Subject: Livestock Water Tank Application - Yoast Pond 011

Application for Livestock Water Tank and Erosion Control Dam

LSWT FIELD CHECKLIST LSWT NAME Yoast 11
 WC completing this form Sarah Myers
 Date of field visit May 15, 2025

StreamStats Report Yoast 11

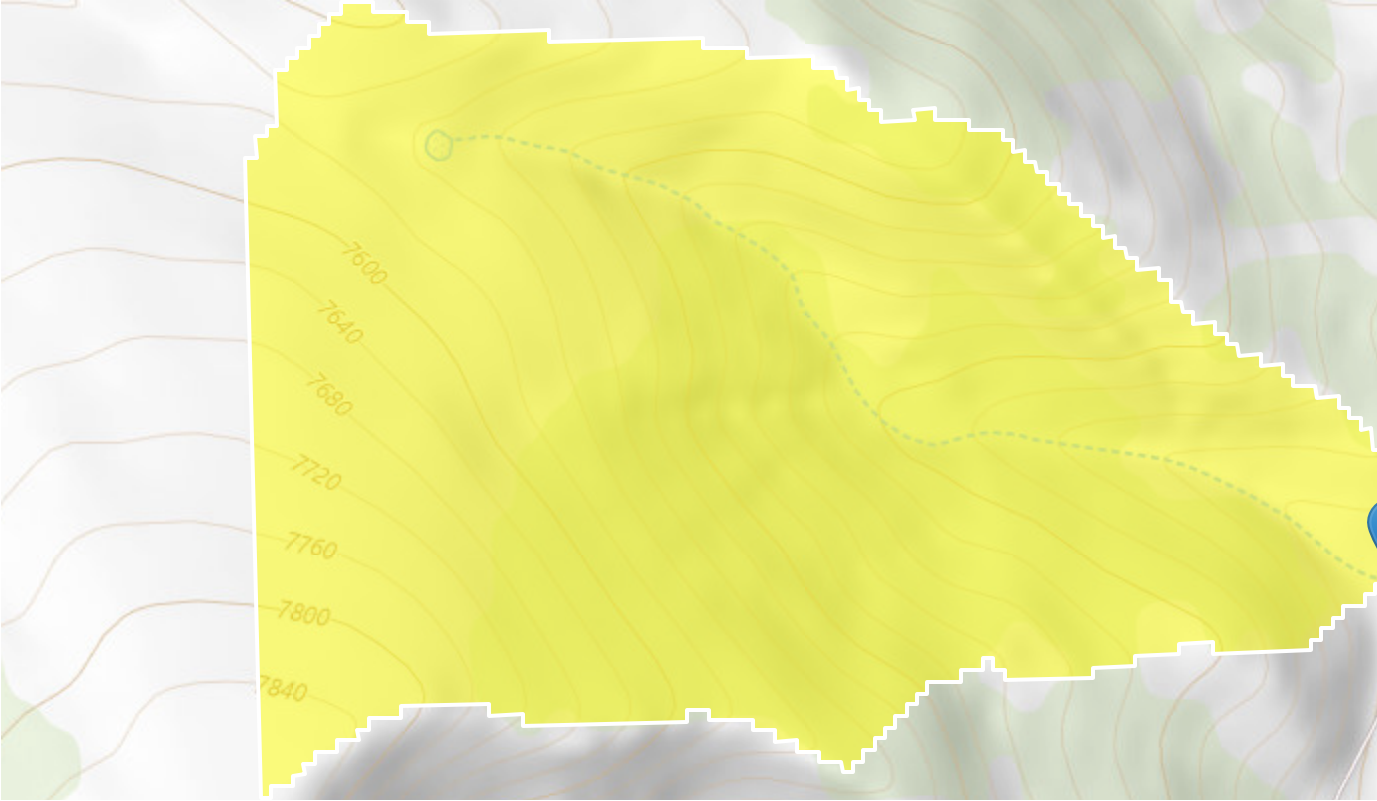
- DWR estimated drainage area (Office Staff). Determine drainage area from USGS Streamstats or other source (acres). Field staff, verify or correct drainage area. 128 acres
- What method was used to estimate the drainage area? USGS Streamstats (results saved
